DEVIATION REQUEST AND DECISION FORM

Project Name : Crossroads Mixed-Use Preliminary Plan
Schedule No.(s) : 5408007005
Legal Description : A portion of Tract B 24/94 Business Park Fil No. 1, as amended by affidavit of correction rec. #219097386

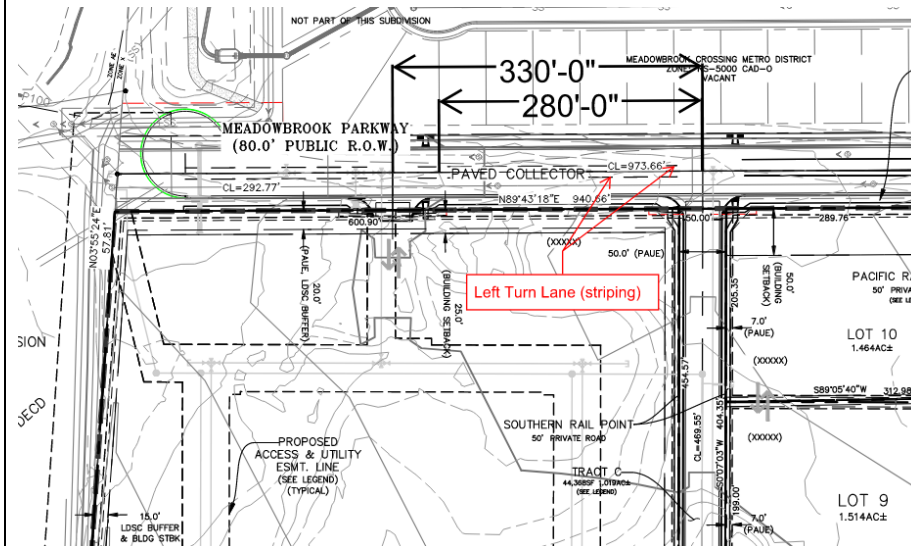
205-foot left turn lane consisting of 155-foot turn lane and 50-foot stacking with a 160' taper is required per the ECM.

330-foot spacing exists between the "West" access (multifamily driveway) on Meadowbrook and the "Middle" access (Southern Rail Point). According to the TIS, there is approximately 280 feet of available space for a westbound left turn lane at the west access due to the proposed location of the middle access.

Alternative Turn Lane Design to provide a 180-foot turn lane and 100-foot taper within the westbound left turn lane at the "west access" to accommodate spacing restrictions.
